Bid Addendum No. 3

PROJECT: The Center - Adaptive Reuse and Tenant Infill

DATE: 4/12/2023

NORTHSTAR PROJECT No. 19-022

Sheet Title: **DOOR & WINDOW SCHEDULE**
Scale: 1/4" = 1'-0"
Status: **CONSTRUCTION DOCUMENTS**
Drawn By: Author
Checked By: Checker
Date Issued: 12-01-2022
Project No: **19-022**
Sheet No: **A111**

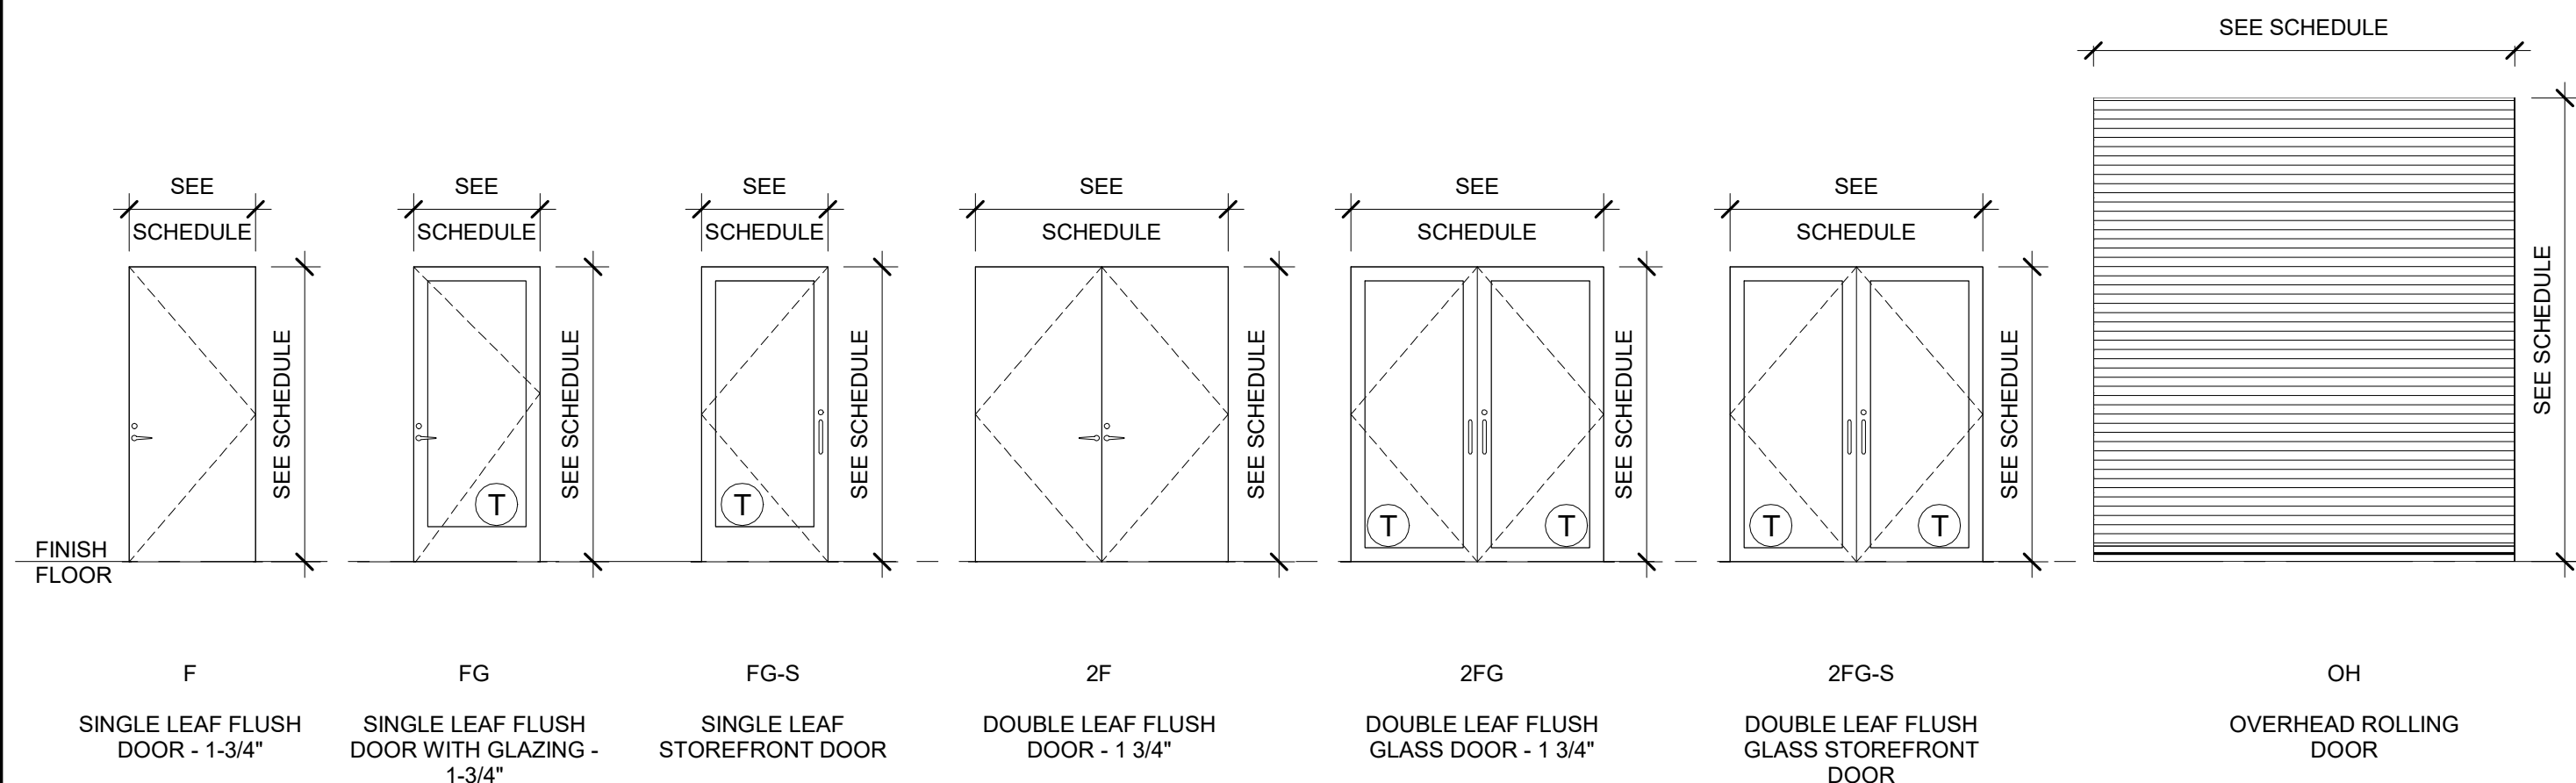
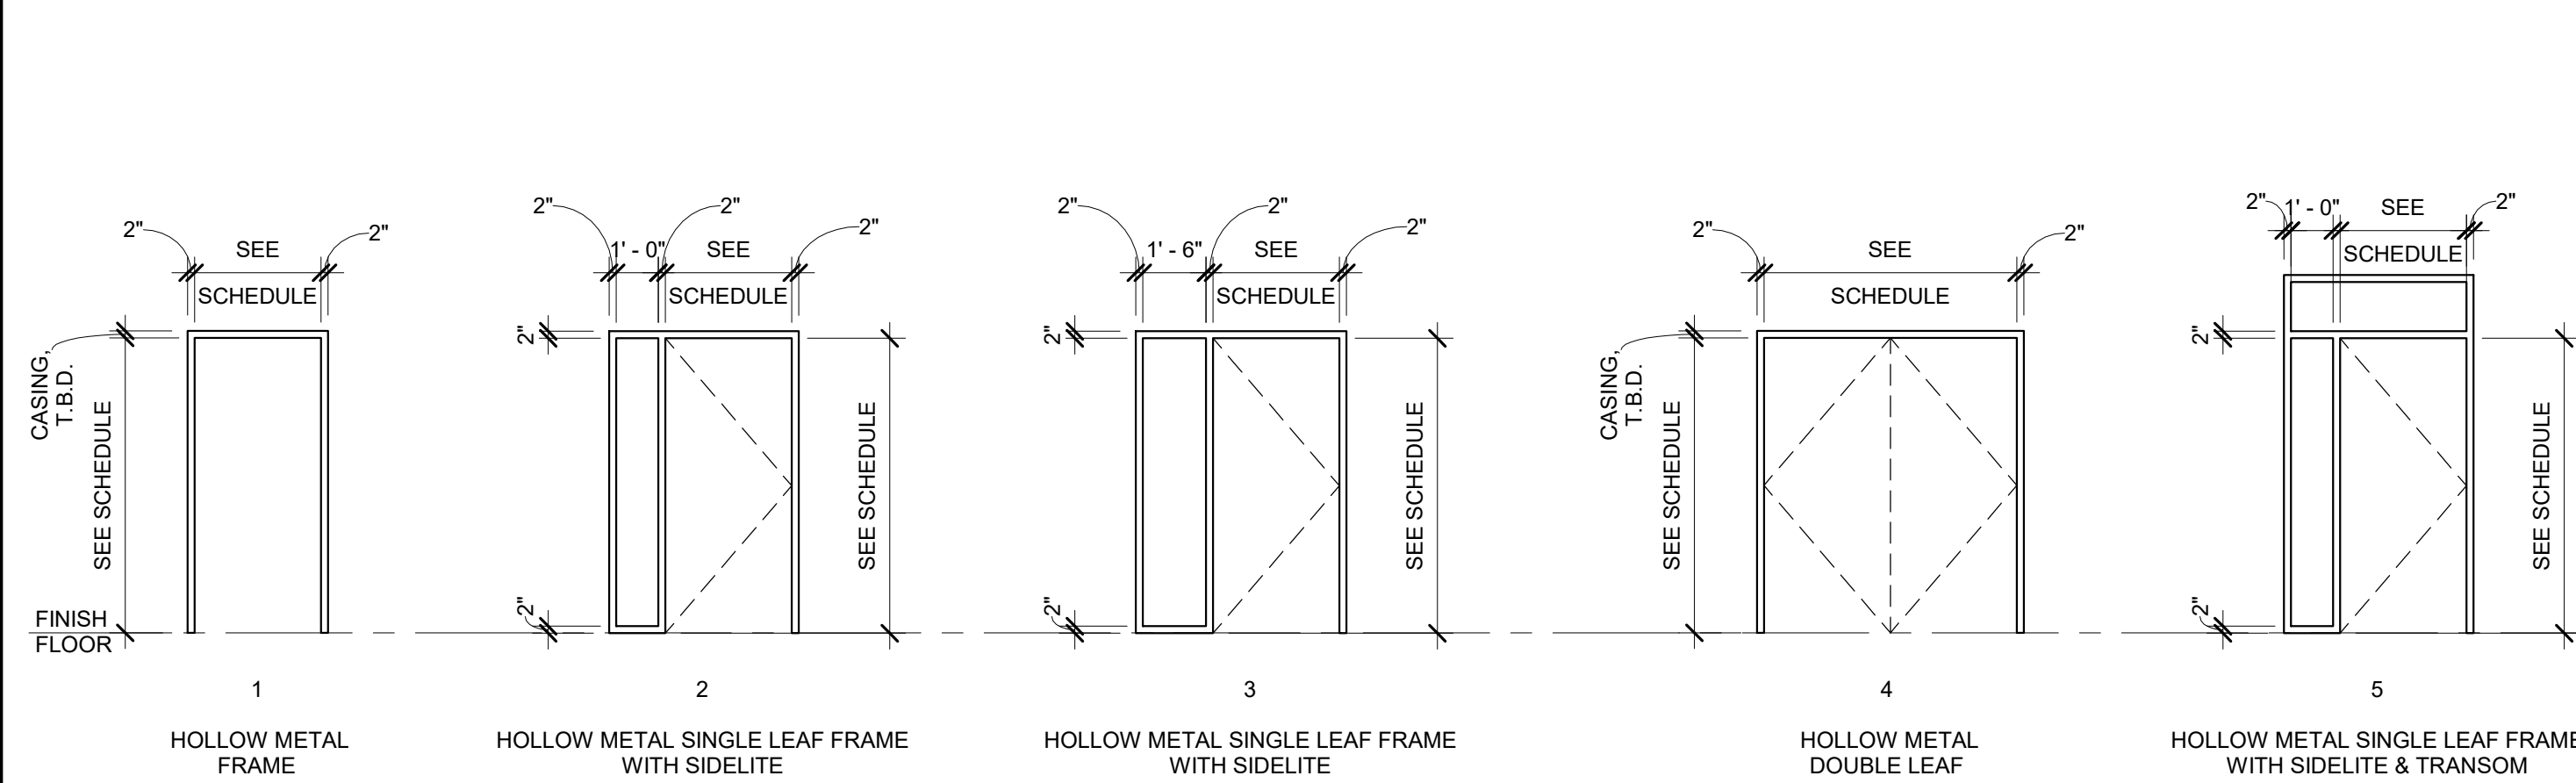
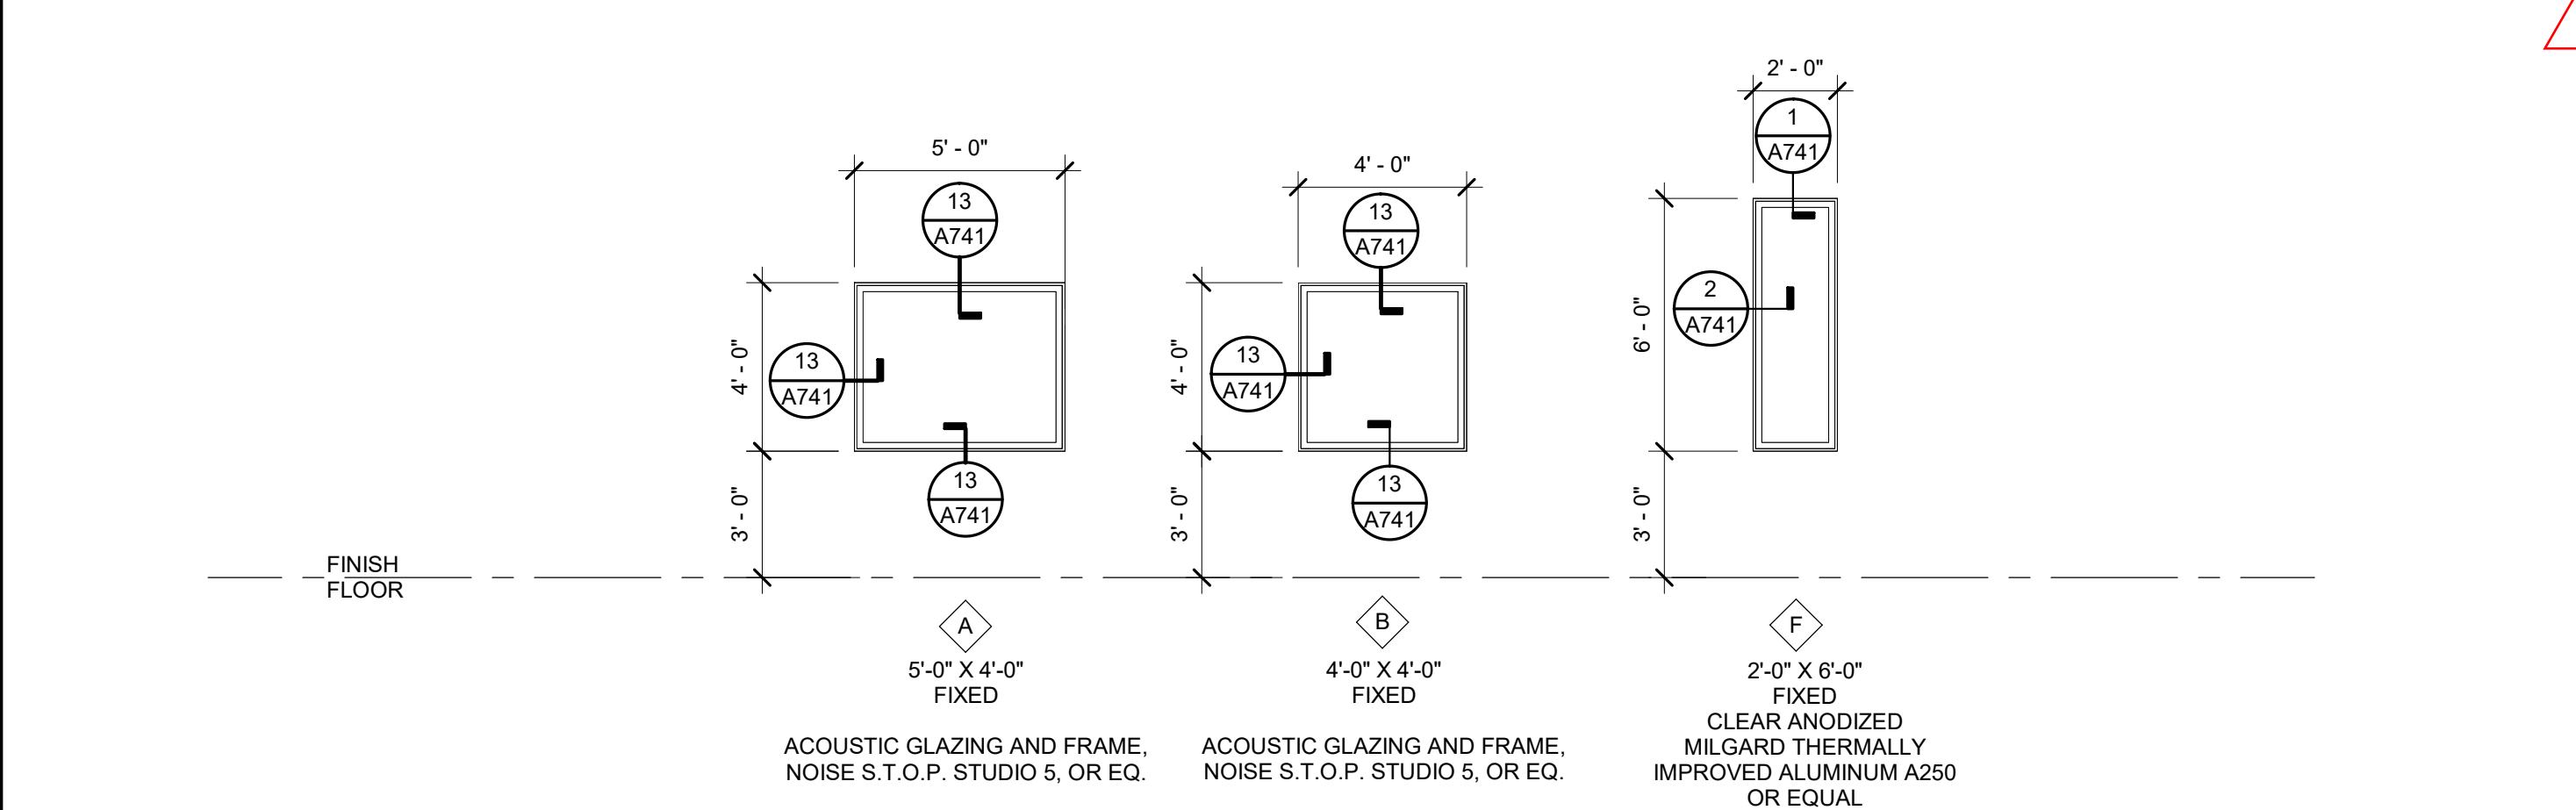
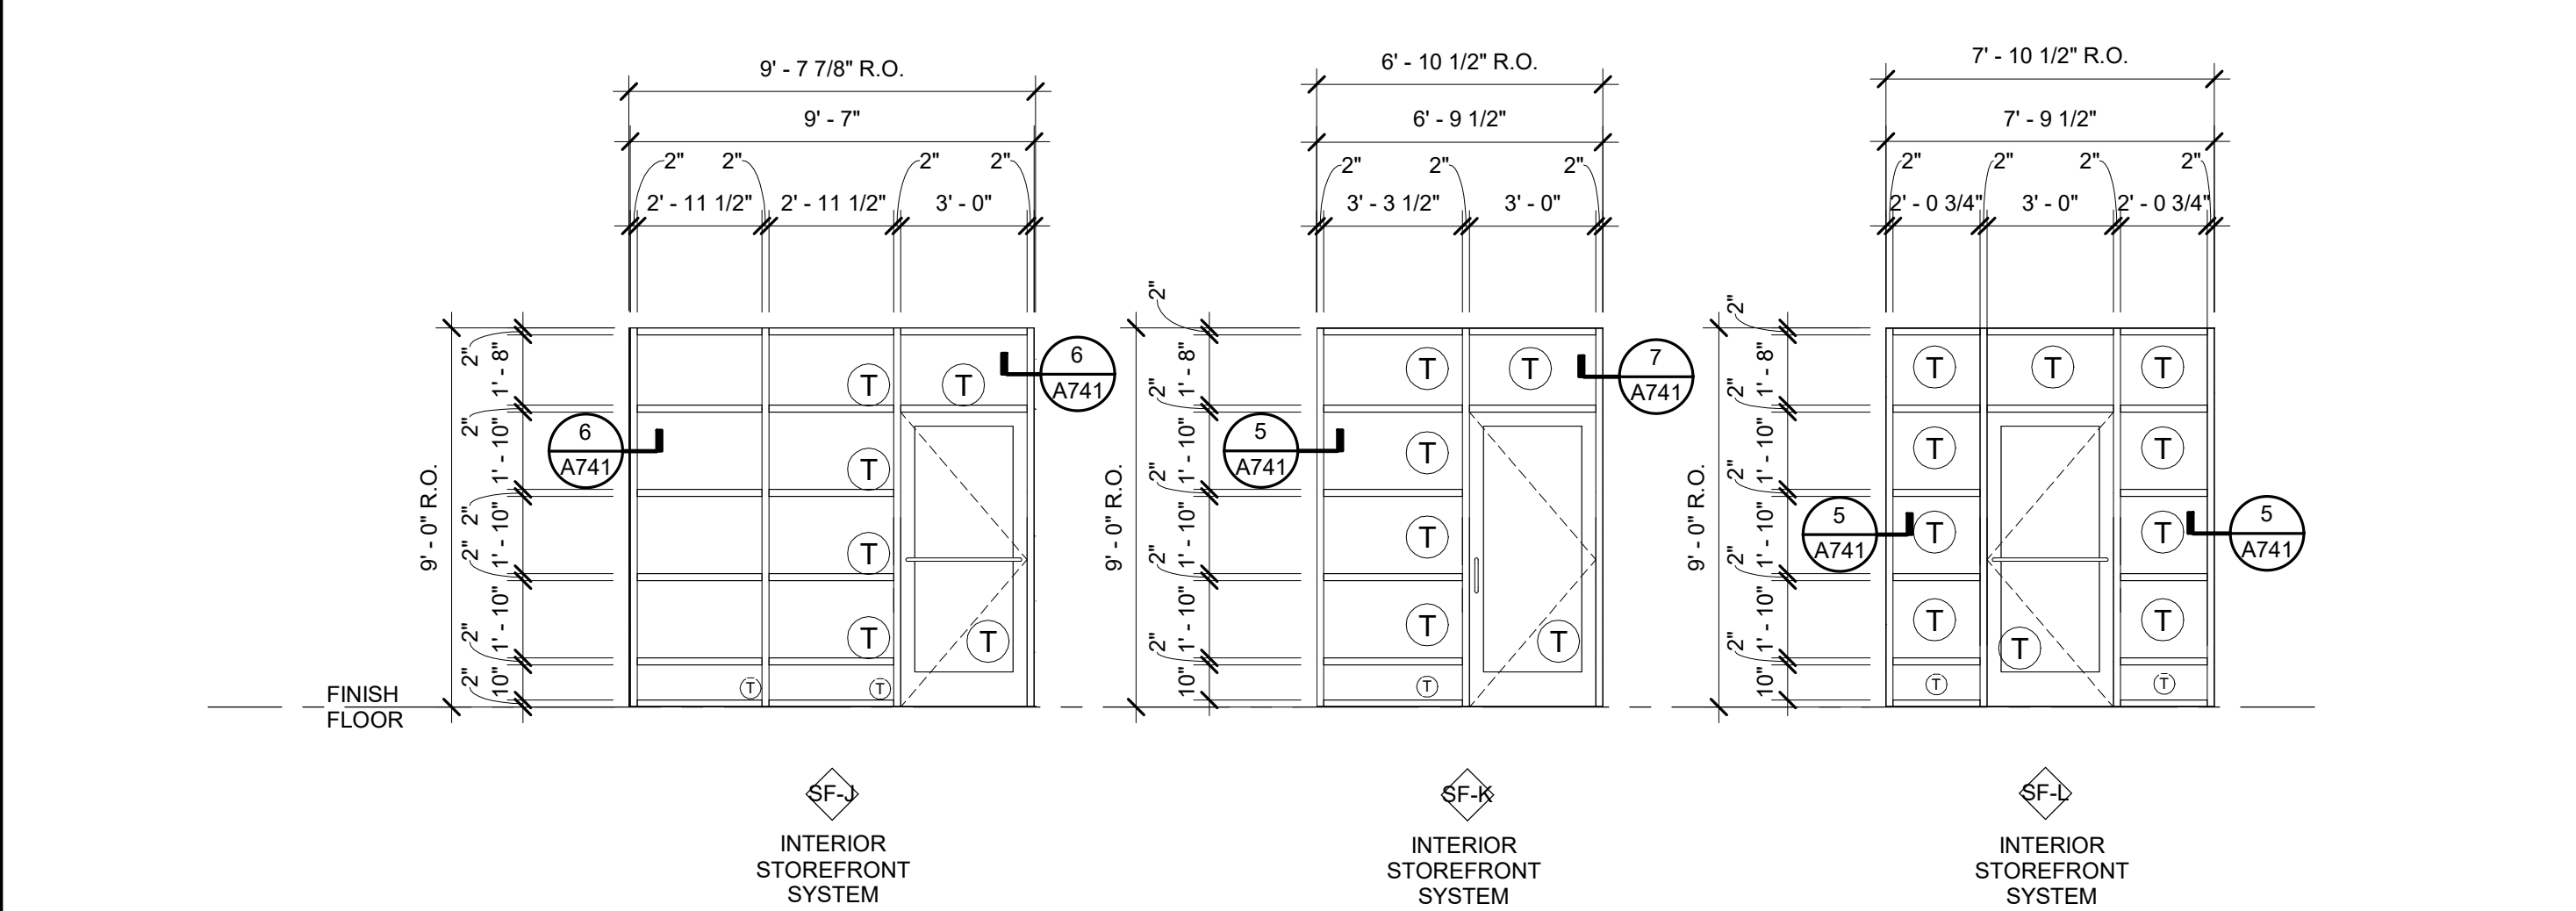
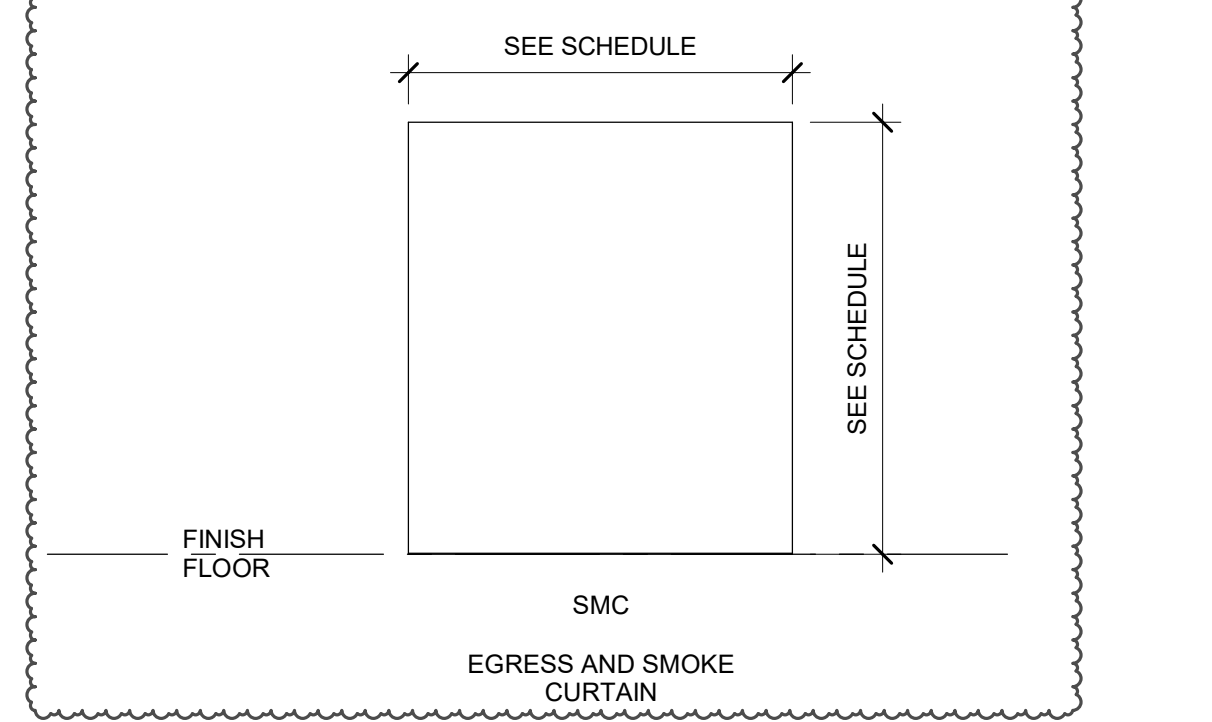
- City Plan Check Comment for room 106 exiting. Revised direction indicator for one (1) illuminated exit sign and adjusted exit occupant loads, see sheets A012 & E231.
- Door 145.B and 146.C width and height corrections, see sheet A111

9. Is the door schedule correct regarding the Overhead Doors?

145.B is called out to be 11' 1.5" X 12' 8" while the existing opening is 10' X 11'
146.C is called out to be 5' 5.5" X 12' 8" while the existing opening is 52.5" X 11'

Response: *The dimensions listed on the door schedule are misleading, they were for maximum width/height including the housing and jamb angles. Existing openings are both 11' tall, one 10' wide and the other 4' wide.*
